DATE: April 2, 2025
SUBJECT: **Detailed Note No. 031 – Red Chris Block Cave Production Phase
Detailed Response to THREAT Technical Memorandum on the Red Chris Block Cave
Feasibility Study Numerical Modelling Report**

TECHNICAL MEMORANDUM

Date: 28 March 2025
To: Ian Austen and Aleksander Purba, Newmont
From: Miguel Fuenzalida and Ehsan Ghazvinian
Re: Responses to Subsidence Report
Ref: 2-5273-02:25TM13

FIGURE TITLE: **FRACTURE LIMITS FOR
BASE CASE AT 0.3%
AND 0.5% TOTAL STRAIN** FIGURE NO: **1**

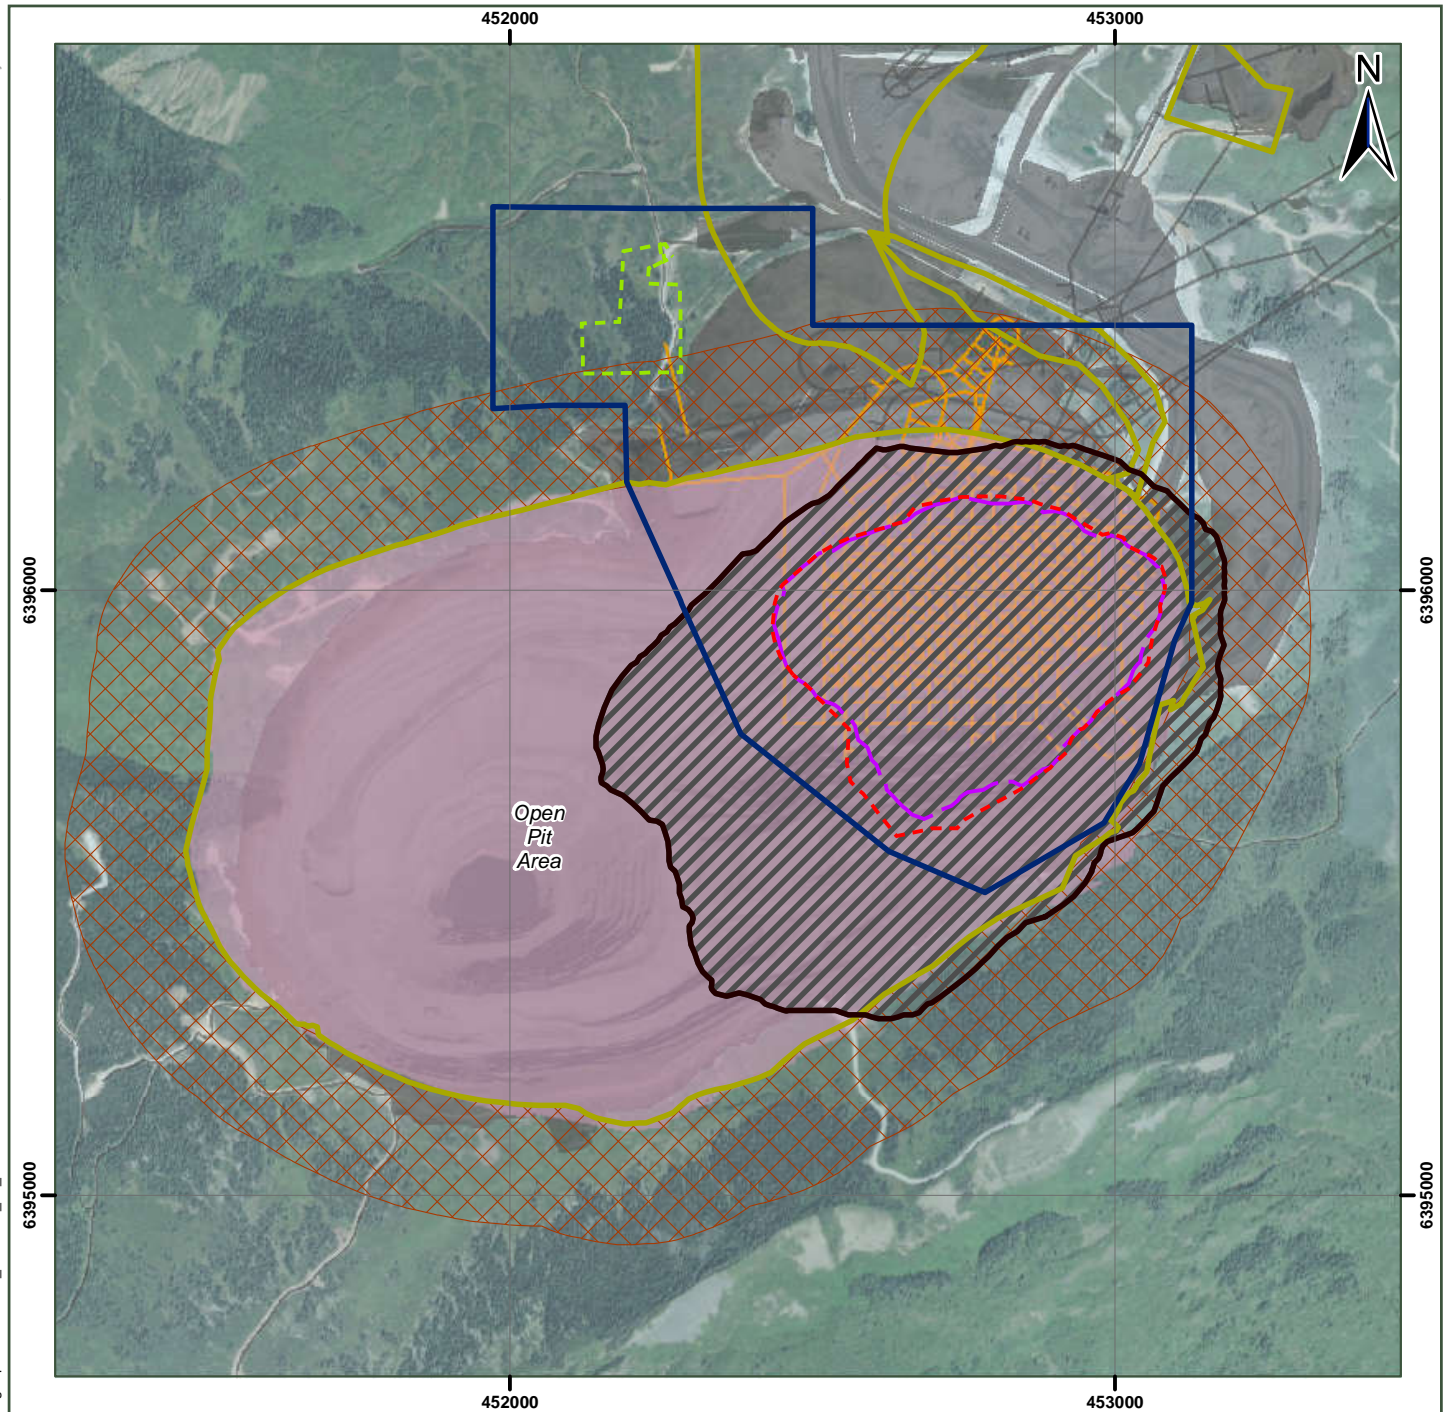
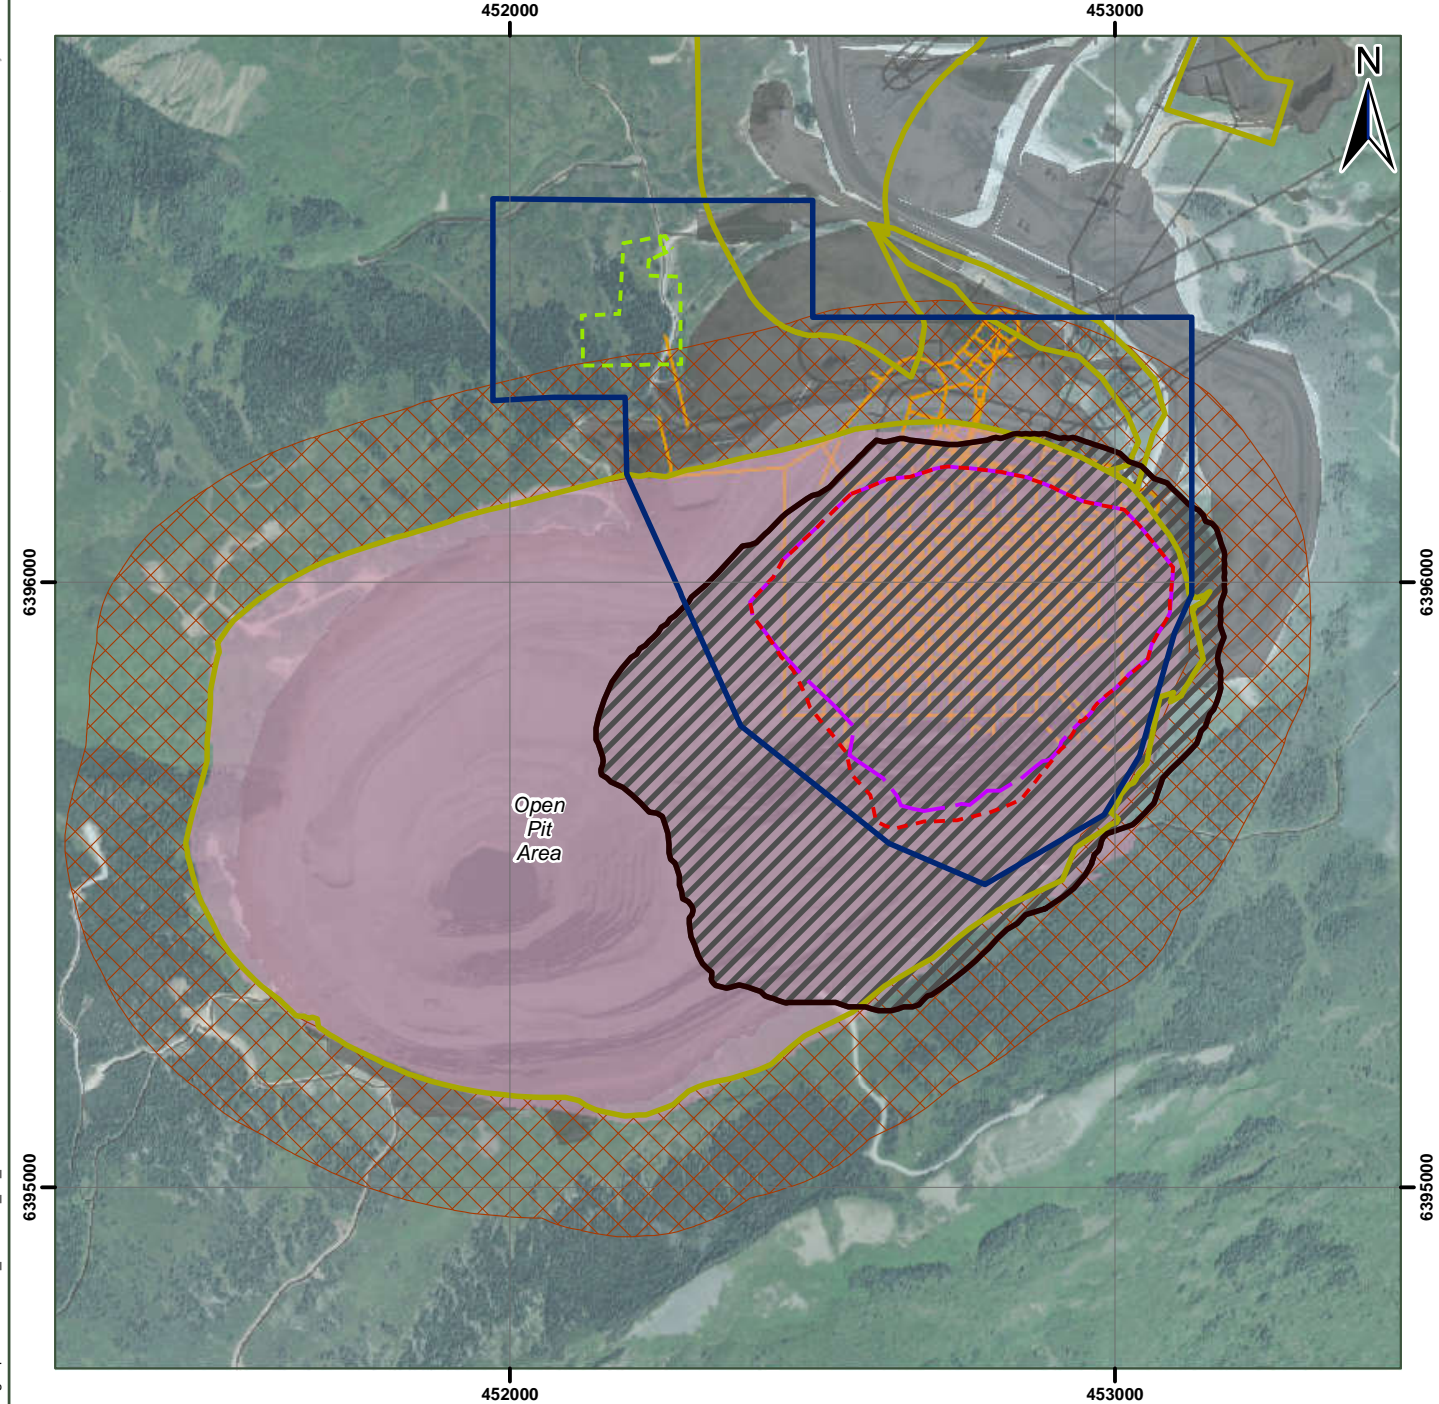
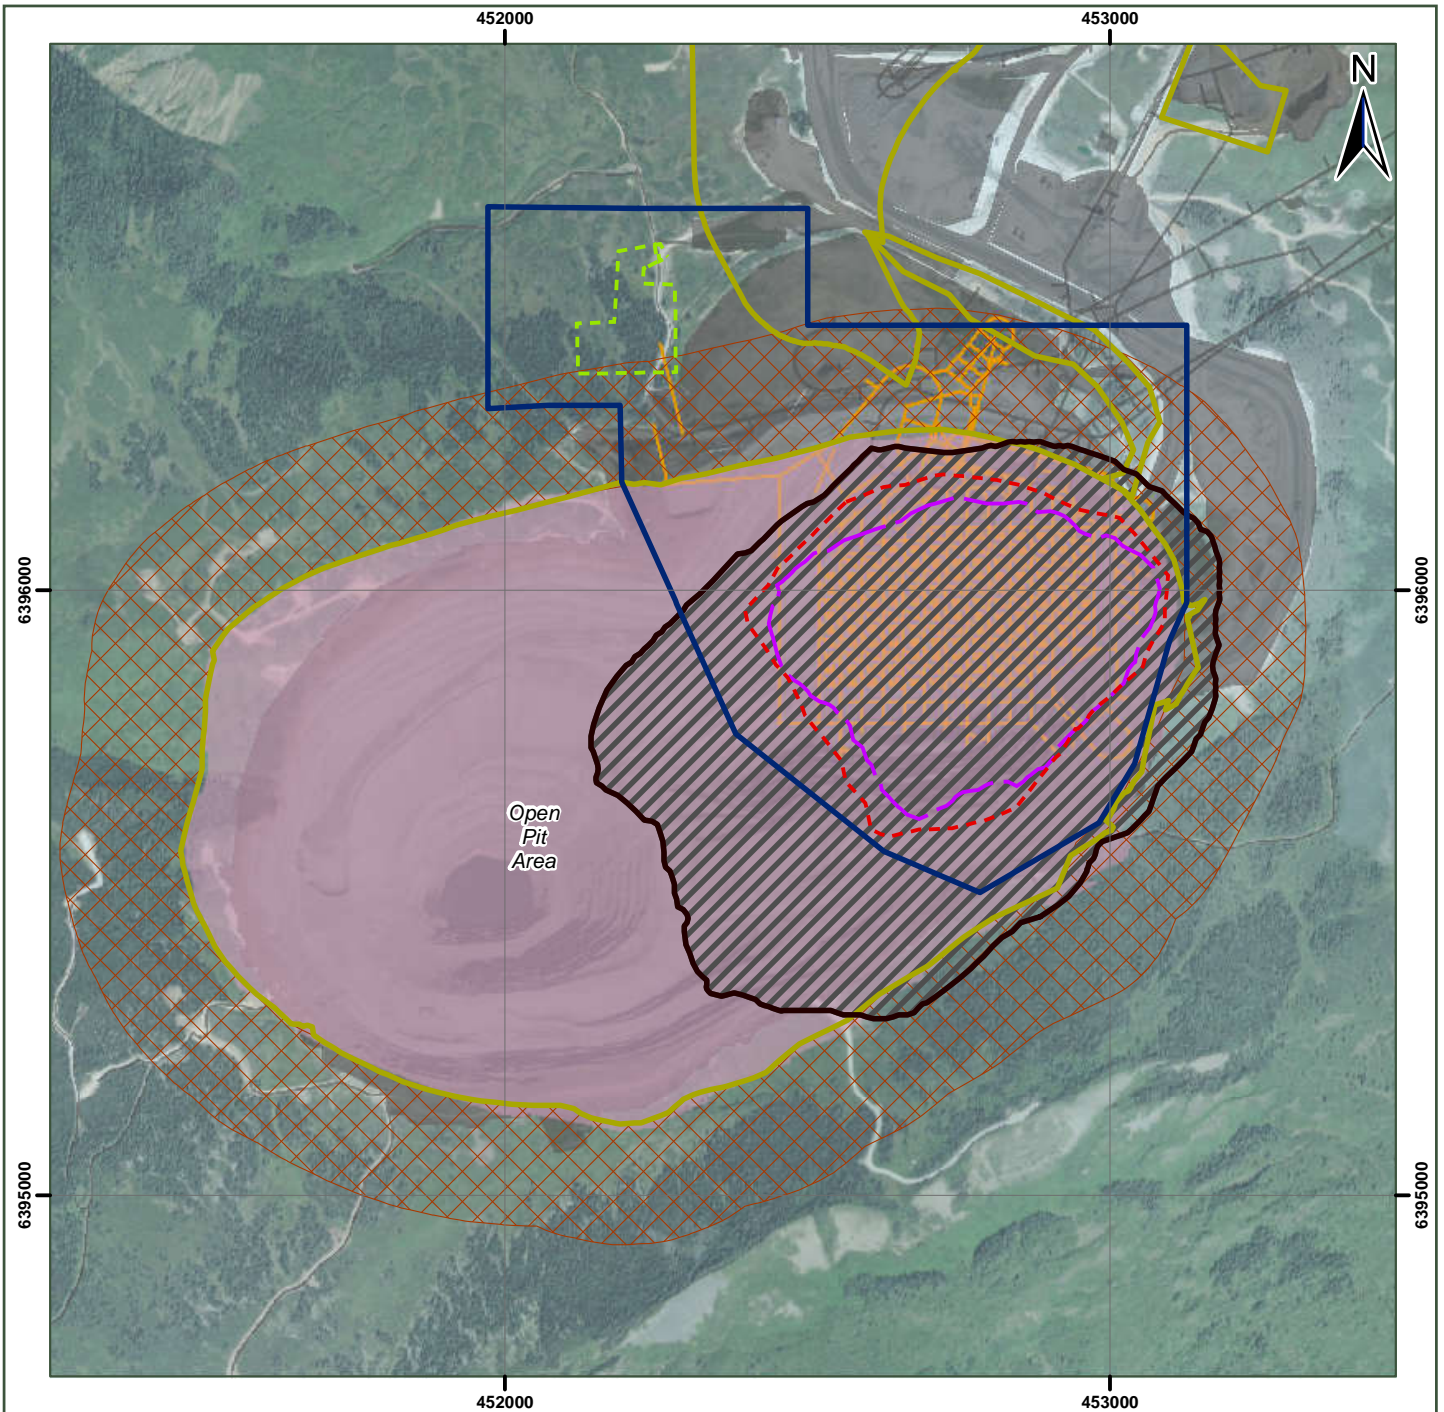
In addition to the written request made in THREAT is Section 2.1 – Definition of fielded Zone (Cave) and Fracturing Zone (Subsidence), NRCML is also providing plan view figures of the fracture limits associated with the ‘Base Case’ and ‘Sensitivity Case’ isosurfaces at 0.3% and 0.5% total strain limits to address the request made by THREAT during the March 5th Red Chris Geotechnical Subsidence Model meeting between NRCML, THREAT, the BC Ministry of Mines and Critical Minerals, and the BC Environmental Assessment Office. These figures are shown below, and include the following:

Between all modelled fracture limits, the extent varies by less than 70 meters and remains primarily within the existing Open Pit, and completely within the ultimate extent of the Open Pit for the Permitted Case. Beyond the ultimate extent of the Open Pit for the Permitted Case, there is no incremental deformation in the previously distributed small-scale displacement zone or the 200 m Closure / Post-Closure exclusion area described in the Amendment Application.

Figure 1. Illustration of how Cavieres et al. (2003) interpreted results of subsidence modelling by plotting strain contours in the range of 0.3% to 0.5%.

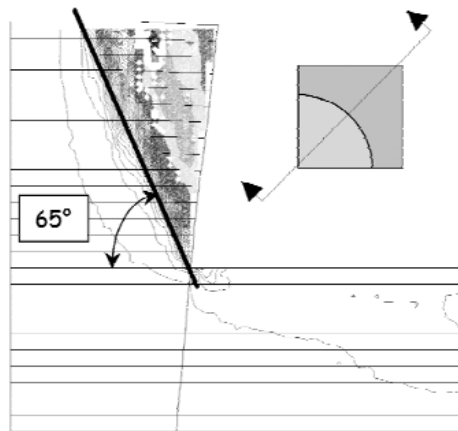
- The paper by Cavieres et al. (2003), cited in the Subsidence Report, does use a 0.3% to 0.5% range for total strain (See Figure 1 below). Furthermore, the same authors state that *“At this point, it is probably reasonable to establish that the 5e-3 “total” strain contour is a representation of the fracturing limit for **average conditions**, but **this limit doesn’t always coincide with the observed subsidence damage.**”* The highlighted text introduces important limitations to the total strain criterion and reinforces the recommendation that a larger range be considered pursuant to application #M05-02.

CLARIFICATION/ACTION (IMPORTANT): Based on this, we are asking for iso-surfaces corresponding to a larger range of total strain (0.3% to 0.5%) to understand the long-term impacts of cave-induced subsidence (i.e., damage does not remain constant over time, as demonstrated by satellite images of Palabora cave-induced pit failure).

In response to reviewer comments, and as requested at the March 5, 2025, meeting, ITASCA has generated additional iso-surfaces and plan views using a more conservative threshold of 0.3% total strain for the base and sensitivity cases. The base case assumes a higher rock modulus (stiffer, harder rock) and the sensitivity case assumes a lower rock modulus (more compressible, softer rock). The fracture limit associated with the base case at a 0.5% total strain threshold was presented in the Amendment Application. The differences between the 0.3% and 0.5% limits are minimal, as expected (see Figures 1–4). The 'Class of Damage' scale included in the iso-surfaces corresponds to the Harrison damage classifications presented on page 58 and 59 of ITASCA (2023).

Figure 3. EW (Top) and NS (Bottom) cross-section at the end of MB1 showing breakthrough and subsidence in terms of fracture limit and crater geometry.

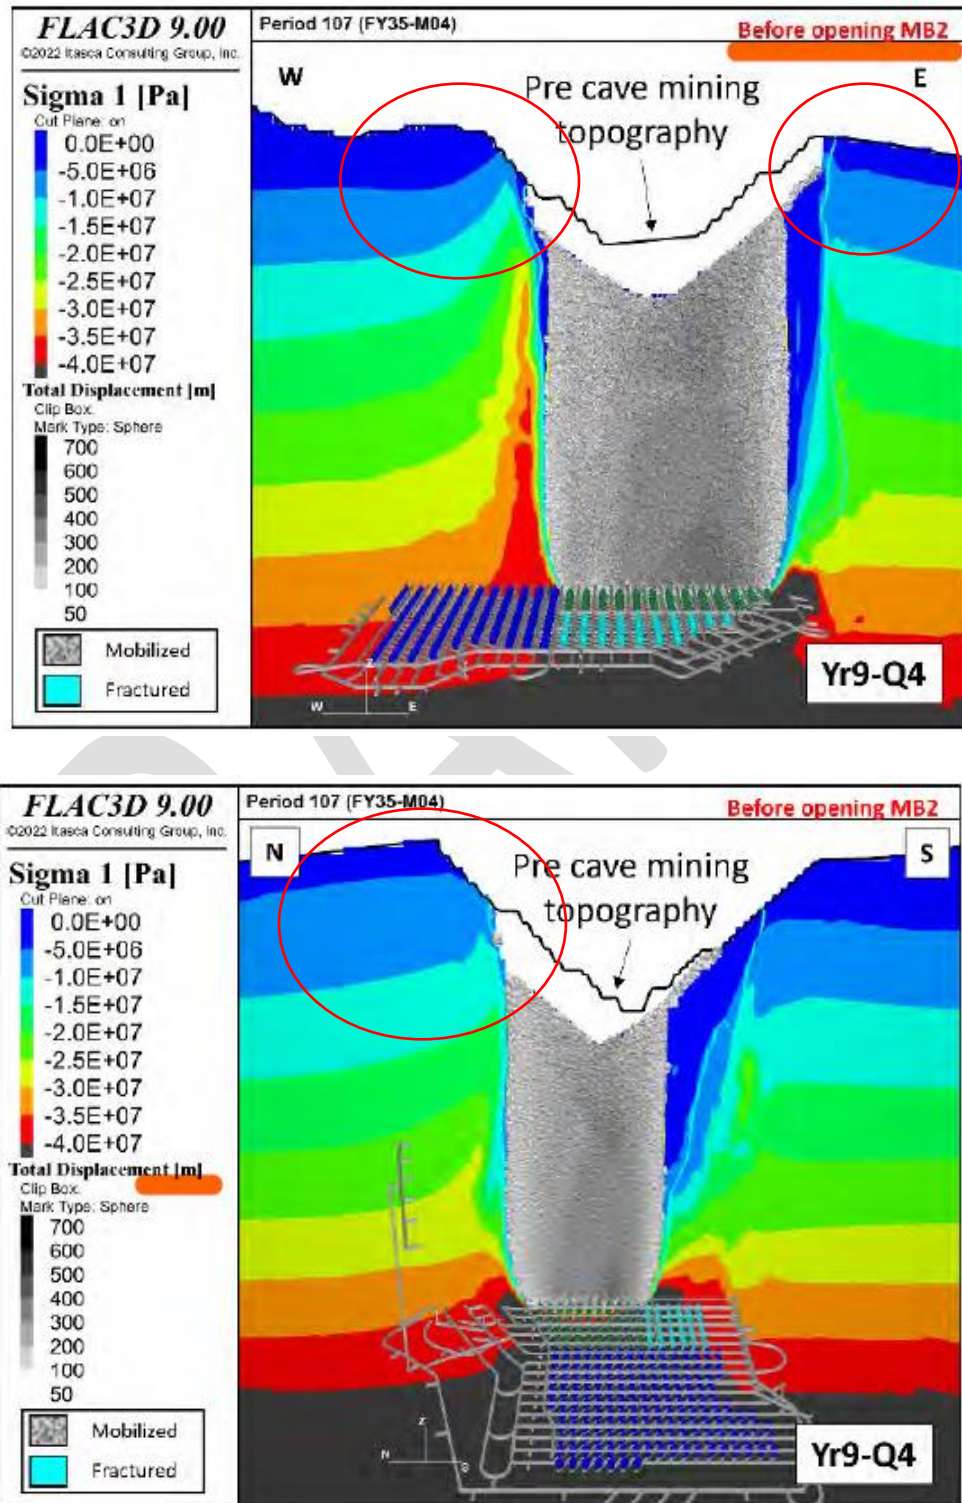
CLARIFICATION: When looking at the section through the pit at the end of MB1 (See Figure 3 below), how much deformation is expected in the zones indicated by the red circles? The results point toward slopes that are steeper than the existing pit walls. A detailed model, including deterministic structures, will be required to confirm the stability of the resulting slopes. It is reasonable to assume that the slope profiles shown in Figure 3 are not more stable than the

current pit slopes. If they were, we could conclude that it is possible to safely steepen the current pit walls and continue with open pit mining down to lower depths.

Figure 4. Original Figure from Harrison (2011).

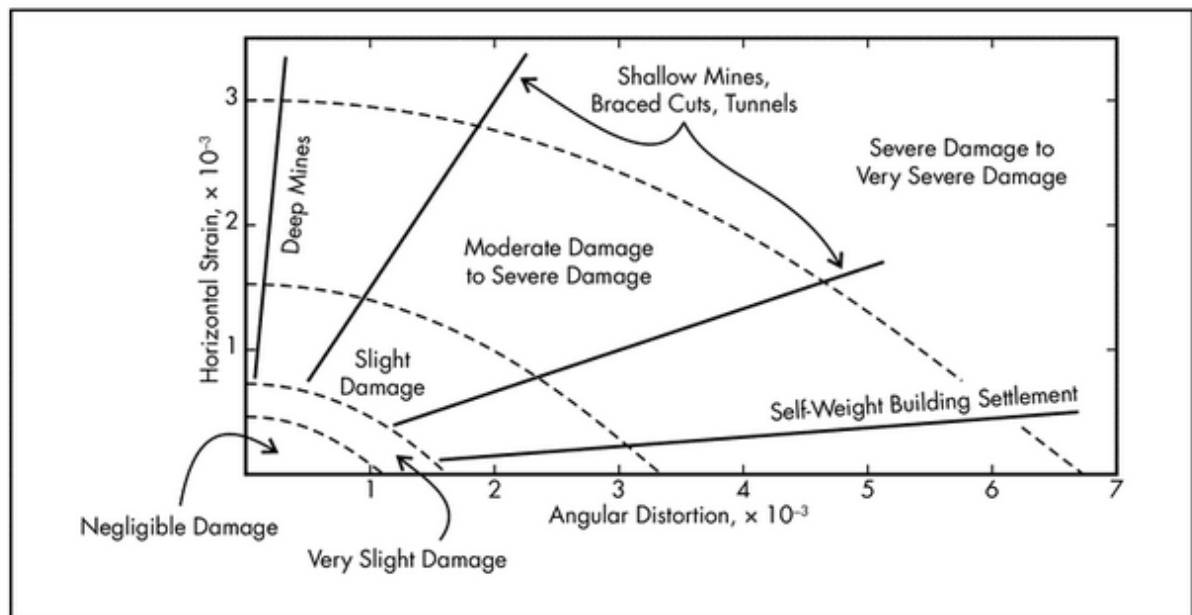
CLARIFICATION: Figure 48 in the Subsidence Report shows the different categories of building damage as determined from a combination of horizontal strain and angular distortion (modified after Harrison, 2011). Using these qualitative categories is reasonable for early screening but not for the final design. Furthermore, Figure 48 specifically refers to damage to infrastructures. Are these qualitative categories suited to studying the impact of subsidence and establishing a non-entry zone specific to land use and wildlife post mining? The Environmental Assessment applications concern impacts beyond structural damage to infrastructures.

CLARIFICATION/ACTION: The y-axis of Figure 48 in the Subsidence Report uses values of strain (horizontal) that are much lower than the assumed total strain threshold of 0.5%. There is further justification to request plots with iso-surfaces of total strain in the range 0.3% to 0.5%. Additionally, plots of horizontal strain using a range of [0.15%, 0.35%] should be displayed for the same cross-sections used in Figure 46 and Figure 57 of the Subsidence Report.

For comments regarding the 0.3% to 0.5% strain range, please refer to Section 2.1 responses.

Figure 5. Damage categories for MB1 (From Figure 49 in the subsidence report).

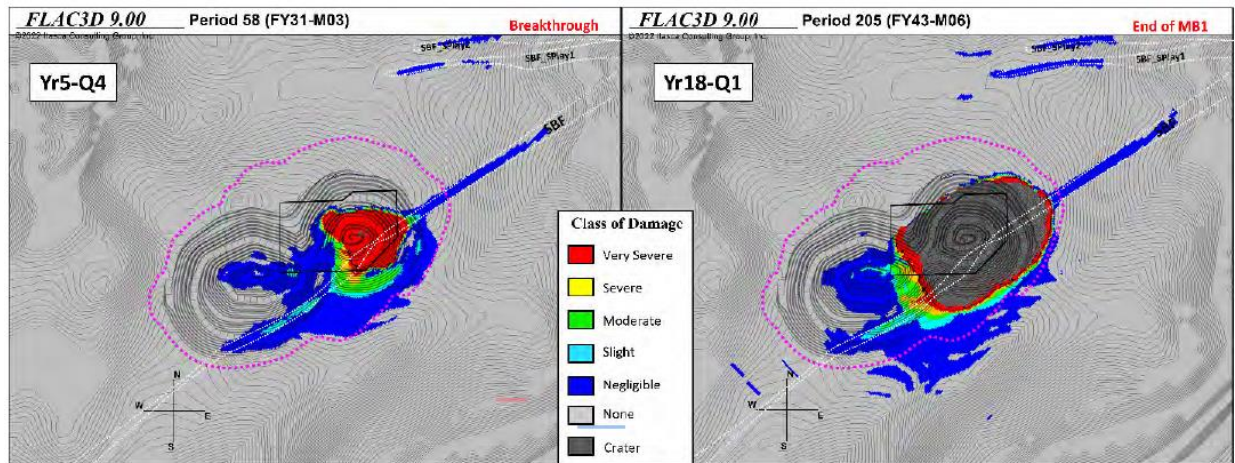
CLARIFICATION: The modelling results (Figure 49 in the Subsidence Report) show that damage would generally not extend beyond the dashed pink line (except for a zone associated with the Bowser unit) under the assumed rock mass conditions. This raises several questions:

- What does the dashed pink line represent?
 - Which zones were used to carry out groundwater studies? How were they defined at depth?
 - Is there any closure or post-closure activity that depends on accessing zones inside the dashed pink line?
 - The subsidence model does not consider a detailed slope analysis. Will further studies examine slope stability in more detail (ideally using a discrete model)?
 - What are the blue zones outside of the dashed pink line (Northeast sector)?,
-
